## DOCUMENT CHANGE REQUEST

DCR number 249

Title: Connectors Electrical Rectangular Non-Removable Solder Bucket PCB and Wire-Wrap Contacts

Number: 3401/001 Issue: 2

Plug Contact Cavity Arrangements — High Density

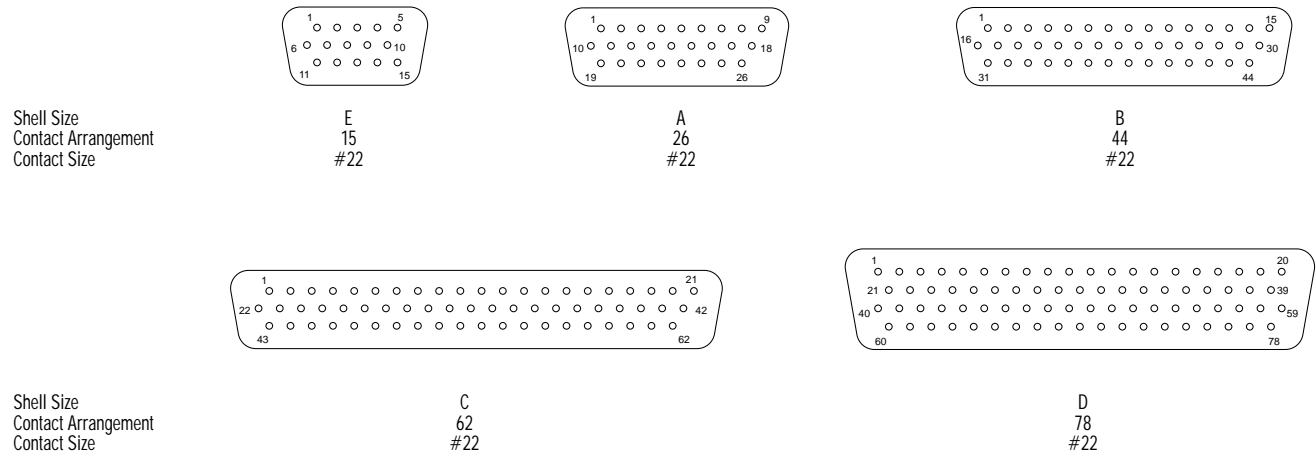
Page 16, Figure 2(b), VARIANT 02-...

In figure 2(b) is presented the contact layout of D-connector 78 Contact, Gauge 22. The contact layout/numbering is incorrect. In picture there are presented incorrectly 79 contacts.

Correct contact layout presented in attachment.
